MODIFICATION SHEET NO. RDSO/2008/EL/ MS/0358, REV.'0'
DATED 27.02.2008

Provision of 16th Notch regression in SMGR in electric Locomotives provided with Roof Mounted DBR.

To increase the effectiveness of roof mounted naturally cooled DBR provided on WAP4 class of Electric Locomotive.

MODIFIED CAM DISC FOR TAP CHANGER NO.- 32	RDSO. ELECT. DTE.	SKEL - 4729, Alt. 'O'	SUPERSEDED BY	SUPERSEDES	✓ FIRST ISSUED

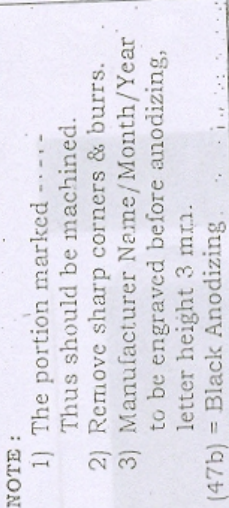
In the present SMGR, 16th notch Cam is not available to incorporate the above modified setting. The modified Cam as per RDSO Drawing No. SKEL-4729, Alt. '0' shall be provided in position 65-66 as per instruction laid down in the Maintenance Manual of M/s. Bombardier.

Modified Cam as per RDSO's Drawing No. SKEL-4729, Alt. '0'
